# Intel<sup>®</sup> Pentium<sup>®</sup> III Processor Specification Update

Release Date: August 2007

Document Number: 244453-058

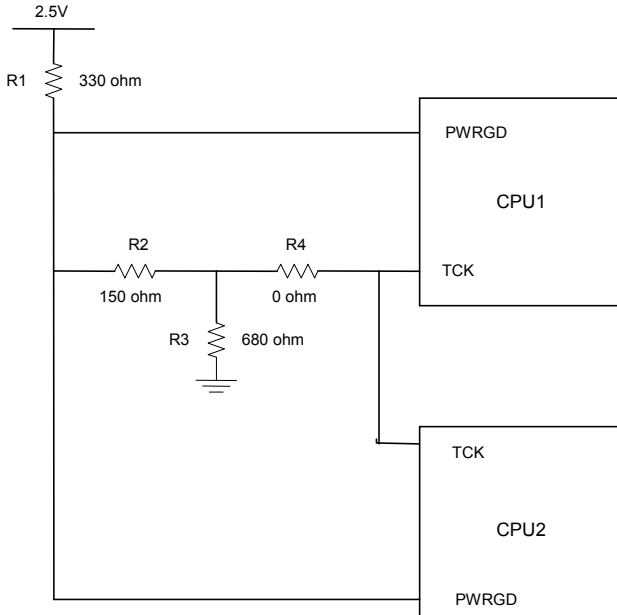
**Problem:** The internal control register bit responsible for operation of the Thermtrip circuit functionality may power up in a non-initialized state. As a result, THERMTRIP# may be incorrectly asserted during de-assertion of RESET# at nominal operating temperatures. When THERMTRIP# is asserted as a result of this erratum, the processor may shut down internally and stop execution but in few cases continue to execute.

**Implication:** This issue can lead to intermittent system power-on boot failures. The occurrence and repeatability of failures is system dependent, however all systems and processors are susceptible to failure. In addition, the processor may fail to stop execution during the event of a valid THERMTRIP# assertion resulting in the potential for permanent processor damage.

**Workaround:** To prevent the risk of power-on boot failures or catastrophic thermal failures, a platform workaround is required. The system must provide a rising edge on the TCK signal during the power-on sequence that meets all of the following requirements:

- Rising edge occurs after Vcc\_core is valid and stable
- Rising edge occurs before or at the de-assertion of RESET#
- Rising edge occurs after all Vref input signals are at valid voltage levels
- TCK input meets the Vih min and max spec as mentioned in EMTS
